H86a_SYNC4_ProPowerOnboard_RELEASED_v1_14_MY21.vsd

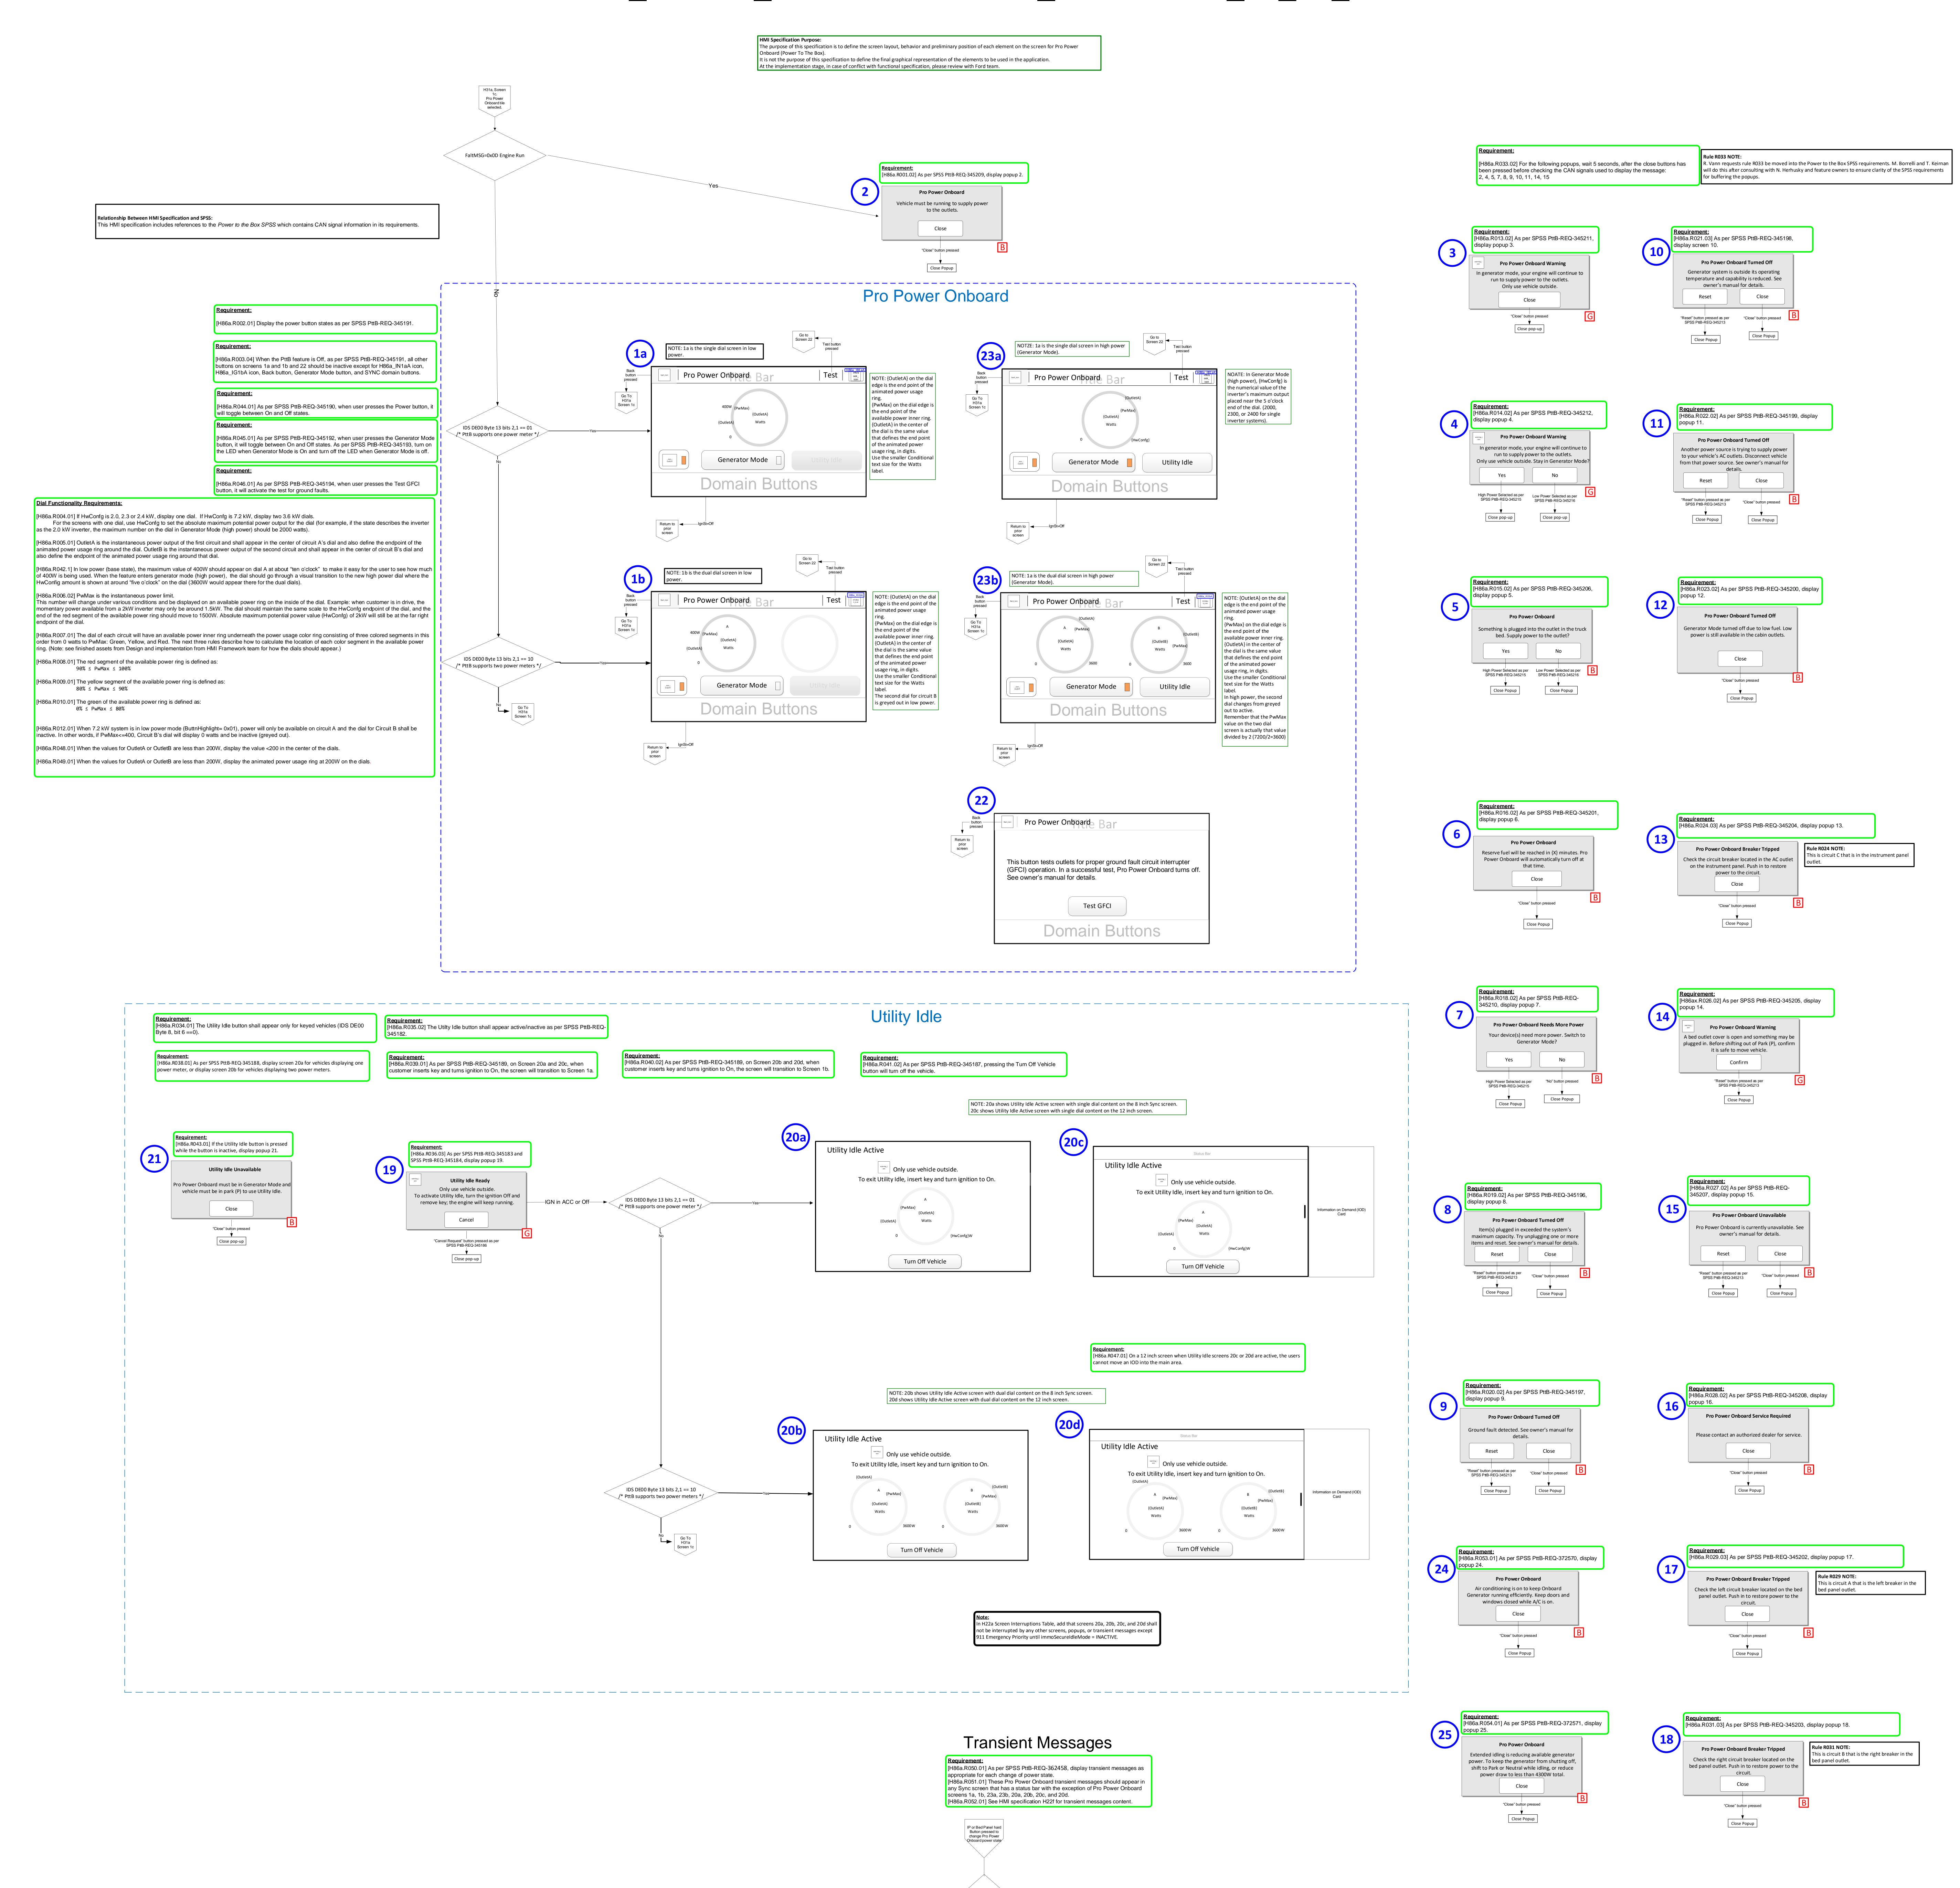
Initial release based on discussions with feature owner and stakeholders Tkeirnan December 7, 2018 Revisions based on discussions with stakeholders to clarify or correct the specification Corrected screen titles in screens 1a and 1b to be "Onboard Generator" instead of "Power to the Box". - As per N. Herhusky, inserted "left" and "right" side description of circuit breakers in the bed outlet area for screens 17 and 18 respectively.

- As per A. Shaukat, altered the dial functionality rules with Matt Kloepf from HMI Foundations team for these rules: R006.01 → R006.02, R007.01 → R007.02, R008.01 → R008.02, R009.01→ R009.02, R010.01→ R010.02, deleted R011.01, R012.01→ R012.02 Clarification for a typo in the title of screen 1b. As per A. Shaukat, no DCR is required. The text string used for screen 1a's title ("Onboard Generator") should be the same string used for screen 1b's title. The titles of both screens should be "Onboard Generator". Translations are not affected. - As per P. Regan, added rules 34-41, 43, and 47 to enable Utility Idle functionality. - As per P. Regan, added screens 19, 20, and 21 to enable Utility Idle functionality. TRANSLATIONS ARE AFFECTED for this new content. - Revised screens 1a and 1b to match Studio's placement of the power button along the same row as the buttons for Generator Mode, Keyless Idle (on keyed trucks only), and Test GFCI. This matches the implementation as per Studio's hero screens. - Revised the power dials in screens 1a and 1b as per J. Mick to clarify Studio's intent for developers. These dials also appear in screens 20a, 20b, 20c, and 20d. Clarified rules R04, R05, and R06 as per T. Keirnan, A. Shaukat, and M. Kloepfer. - As per R. Vann and G. Cheng, revised **all** rules that referred to CAN signals so that no CAN signals are mentioned in the HMI spec. In this new method of doing HMI specs, HMI rules refer to requirements in M. Borrelli's *Power to the Box SPSS* that explain which signals relate to the HMI. Thus CAN signals can change without the - Added rule R042 as per J.Mick and S. Dhawan to clarify how the power dials should work with the 400W value and then the high power value. Added rule R044 to clarify the power button behavior. - Added rule R045 to clarify the Generator Mode button behavior. - Added rule R046 to clarify the Test GFCI button behavior. - As per M. Borrelli, deleted text in rules that should now be covered in the SPSS requirements along with CAN signals information. Revised popups 9 and 12 title text from "Onboard Generator turned off" to "Onboard Generator Turned Off" (translations not affected for those) - NOTE: We are having translation issues with the design of Screens 1a and 1b regarding both button placement and button text. A future release may request changes to those things, but not to the logic of how the Onboard Generator and Utility Idle features work.

- As per C. Cundiff and T. Keirnan, deleted the Test GFCI button from screens 1a and 1b and put a "Test" link in the top right corner alongside the Infobook icon. This "Test" link leads to new screen number 22 for ground fault testing purposes and is going to be easier for translation into longer languages. The DCR # in Jira for this is

- Clarified button location for screens 1a and 1b so that the power button, Generator button, and Utility Idle buttons are evenly spaced across. Also as per clarified location of Test GFCI button on screen 22 so that it is in the same general vertical area as buttons on screens 1a and 1b.

- For Jira ticket #56050 as per N. Sultana and N. Herhusky, changed the body text in popup 10 from "Generator system temperature limit exceeded. See owner's manual for details." to "Generator system is outside its operating temperature. See owner's manual for details."
- For clarification, all references to the back button icon's label have changed from "_icon_:System-Back" to "back_icon". The actual icon image hasn't changed. For clarification, all references of the infobook button's icon have changed from "_icon_:Pttb - Information" to "infobook_icon". The actual icon image hasn't changed. For clarification, all references to the warning icon have changed from "[icon]: Settings - Hazard Warning" to "warning_icon". The actual icon image hasn't changed.

- As per S. Dhawan and M. Borrelli, clarified rules for popup 19. We moved rule R037.02's reference to "SPSS PttB-REQ-345184" into rule R36.03 and then deleted rule R37 because the reference to SPSS PttB-REQ-345186 in it is already covered in the arrow below the popup that points to Close Popup. No functional change results from this, merely condensing of the existing rules to solve some confusion. - As per S. Dhawan, added screens 23a and 23b to clarify for developers how the single and dual dials move from low power to high power states. - As per J. Mick and S. Dhawan, clarified the inner available power ring definitions in rules 8, 9, and 10. Gathered all Utility Idle screens and popups into their own area labeled "Utility Idle" for easier reading.

- As per P702 UX PAT on June 6, revised text in popup 14 from "Something is plugged into the truck bed outlet. Confirm it is safe to move your vehicle before shifting out of Park (P)." to "A bed outlet cover is open and something may be plugged in. Before shifting out of Park (P), confirm it is safe to move vehicle."
- As per C. Bloxsom in ASO, revised text in screen 22 from "This button tests outlets for safety by causing a temporary ground fault. In a successful test, Onboard Generator turns off. See owner's manual for details." to "This button tests outlets for proper ground fault circuit interrupter (GFCI) operation. In a successful test, Onboard Generator turns off. See owner's manual for details."

Added rules R048 and R049 for mitigating the inaccuracy of the feature's reported wattage values below 200W.

- Changed body text of popup 6 from "Operating on reserve fuel. Onboard Generator will automatically turn off in {X} minutes. Keep Onboard Generator running?" to "Reserve fuel will be reached in {X} minutes. Onboard Generator will automatically turn off at that time." Also deleted the Yes and No buttons and replaced them with a

Changed text of popup 12 from "Onboard Generator turned off due to low fuel. Use reserve fuel to supply power to the outlets?" to "Generator Mode turned off due to low fuel. Low power is still available in the cabin outlets." Also deleted the Yes and No buttons and replaced them with a Close button.

Deleted reference to popup 12 in Rule 33 so that popup 12 does not need to wait five seconds when user presses Close. H86a.R033.01 becomes H86a.R033.02 and is now looking like this without popup 12 in it: [H86a.R033.02] For the following popups, wait 5 seconds, after the close buttons has been pressed before checking the CAN signals used to display the message:2, 4, 5, 7, 8, 9, 10, 11, 14, 15

- Added Transient Messages rules R050, R051, and R052. The other two HMI specifications for transient messages, H22e and H22f, will have updates soon to complete this DCR's requirements and I will notify IVI.

• As per DCR SYNC-80082, changed rule "[H86a.R003.02] When the PttB feature is Off, as per SPSS PttB-REQ-345191, all other buttons on screens 1a and 1b should be inactive except for H86a_IN1aA icon, H86a_IG1bA icon, Back button, and SYNC domain buttons." to "[H86a.R003.03] When the PttB feature is Off, as per SPSS PttB-REQ-345191, all other buttons on screens 1a and 1b should be inactive except for H86a_IN1aA icon, H86a_IG1bA icon, Back button, Generator Mode button, and SYNC domain buttons." The only difference is adding "Generator Mode" button" to be active when the PttB power button is Off. As per DCR SYNC-83702, changed the text in popup 10 (from rule [H86a.R021.02)] from "Generator system is outside its operating temperature. See owner's manual for details." to rule [H86a.R021.03)] "Generator system is outside its operating temperature and capability is reduced. See owner's manual for details." Corrected/clarified the revision log for v1_08 by changing the references to rules R050 and R051 to R048 and R049, respectively. Corrected/clarified the transient message numbers referred to from 9700/9701/9702 to 9800/9801/9802 in the diagram for the Transient Messages area of this specification that supports rules

Per Ron Puri and Isaac Emesowum, added clarifications that do not require a DCR. Clarified screen 23B's left dial that was incorrectly labeled B when it should be labeled A. Clarified that Rule H86a.R003 applies to screen 22 as well as to screens 1a and 1b. H86a.R003.03 -> H86a.R003.04 with the addition of the words "and 22" after the words "screens 1a and 1b".

* As per Azhar Piracha (Cross Vehicle Marketing Manager) email message on October 17, changed the name of the feature in all screens in this specification from Onboard Generator to Pro Power

* As per Laura Check and Mustapha Mourtada, the simple breakers popup changes were removed from the larger DCR 97788 for FHEV derating solutions and placed in their own DCR. During testing HMI and Feature Owners discovered the SPSS rules are mismatched to the correct popup messages. This would result in confusion for the customer when they are told a particular circuit breaker has tripped and they shoud push it in, when it is in fact a different circuit breaker that tripped. * No CAN signals are changed or added. Changes are simply to point the correct popup messages to the correct SPSS rules and add consistent action text to one of the popup messages so they * For popup 13, Rule H86a.R024.02 → H86a.R024.03 by switching SPSS rule 345202 with rule 345204, which is the appropriate SPSS rule for circuit C's breaker that should be on the IP outlet.

* On popup 13, added text to be consistent with the other two breaker resetting popups (17 and 18) to read "Push in to restore power to the circuit." * On popup 17, Rule H86a.R029.02 H86a.R029.03 by switching SPSS rule 345203 with rule 345202, which is the appropriate SPSS rule for circuit A's breaker that should be on the left in the bed * On popup 18, Rule H86a.R031.02 -> H86a.R031.03 by switching SPSS rule 345204 with rule 345203, which is the appropriate SPSS rule for circuit B's breaker that should be on the right in the

* As per DCR 88542, added rule "[H86a.R053.01] As per SPSS PttB-REQ-372570, display popup 24." to control popup 24, and added new popup message number 24. * As per DCR 97788, added the sentence "See owner's manual for details." to popup message number 8. The owner's manual should now include text about the 7.2kW truck not just overloading a sircuit beyond 3600W and shutting down the feature, it should also discuss the 5.7kW limited max power while in Drive, and the possibility of derating below 5.7kW in hot weather and prolonged * As per DCR 97788, added new popup number 25 that states "Extended idling is reducing available generator power. To keep the generator from shutting off, shift to Park or Neutral while idling, or As per DCR 97788, added new rule "[H86a.R054.01] As per SPSS PttB-REQ-372571, display popup 25." to control popup 25, and added new popup message number 25.
